Agenda Item # 3 SUB-003147-2024

Parks Subdivision

- Subdivision approval to create one (1) legal lot of record from three (3) metes-and-bounds parcels and two (2) legal lots of record.

APPLICATION NUMBER 3 DATE December 19, 2024

DETAIL SITE PLAN

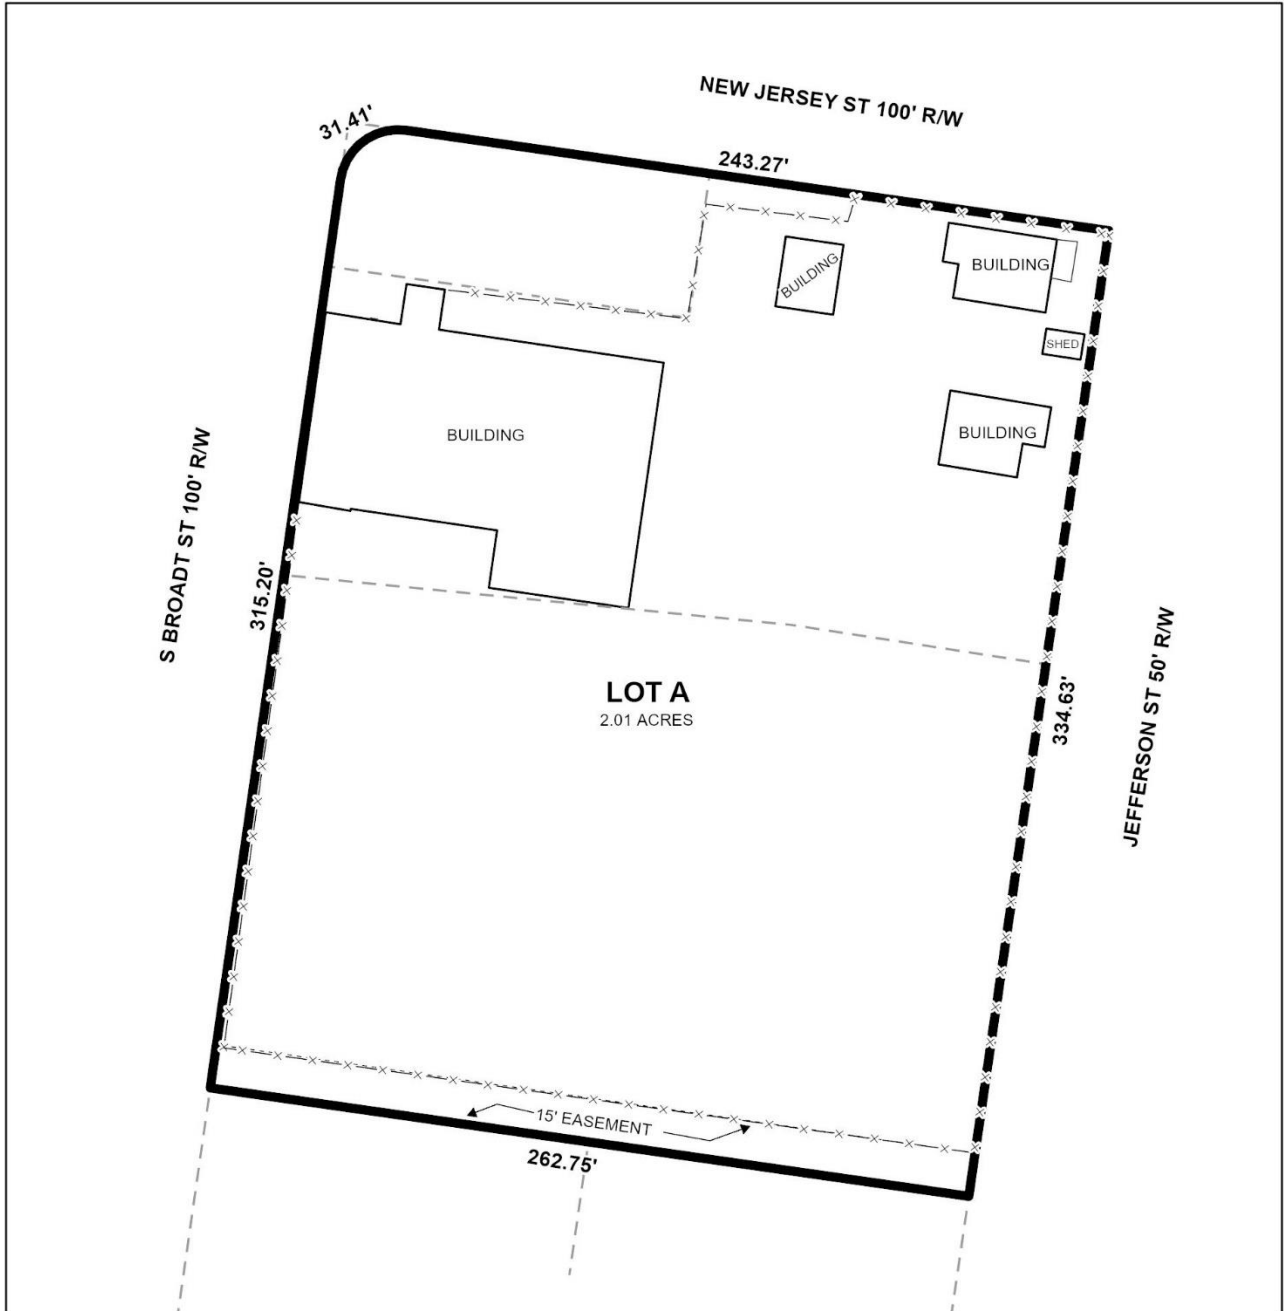
- B. Show and label the MFFE (Minimum Finished Floor Elevation) on each lot that contains an A, AE, or X (shaded) flood zone designation. BFE = 12.
- C. Revise NOTE #5 – delete "...CITY OWNED...".

- D. Revise NOTE #7 to read "As shown on the 1984 aerial photos LOT A will receive 58,000 sf of historical credit of existing (1984) impervious area towards stormwater detention requirement per Mobile City Code, Chapter 17, Storm Water Management and Flood Control)."

The site is a corner lot with two (2) corners, each requiring a 25-foot corner radius. The preliminary plat illustrates a compliant corner radius where South Broad Street and New Jersey Street intersect; however, no corner radius is provided where New Jersey Street and Jefferson Street intersect. As such, if approved, the Final Plat should be revised to illustrate dedication sufficient to provide a 25-foot corner radius where New Jersey Street and Jefferson Street intersect, unless a waiver of Section 6.C.6. of the Subdivision Regulations is recommended by the City Engineer and Traffic Engineer.

No front yard setback is illustrated along any street frontage, as required by Section 5.C.2.(i) of the Subdivision Regulations. A minimum 10-foot front yard setback is required for lots within a B-3 Urban district, per Article 2, Section 64-2-14.E. of the Unified Development Code. If approved, a minimum 10-foot front yard setback should be illustrated along all street frontages on the Final Plat, adjusted for any required dedication.

Multiple buildings encroach within the 10-foot front yard setback and are non-conforming. It should be noted that any future development or redevelopment of the property may require compliance with current regulations.

1. Retention of all rights-of-way widths on the Final Plat, as depicted on the preliminary plat;
2. Revision of the Final Plat to illustrate dedication sufficient to provide a minimum 25-foot corner radius where New Jersey Street and Jefferson Street intersect, unless a waiver of Section 6.C.6 is granted by the Planning Commission;

4. Revision of the Final Plat to illustrate a 10-foot front yard setback along all street frontages, in compliance with Section 5.C.2.(i) of the Subdivision Regulations and Article 2, Section 64-2-14.E of the Unified Development Code;
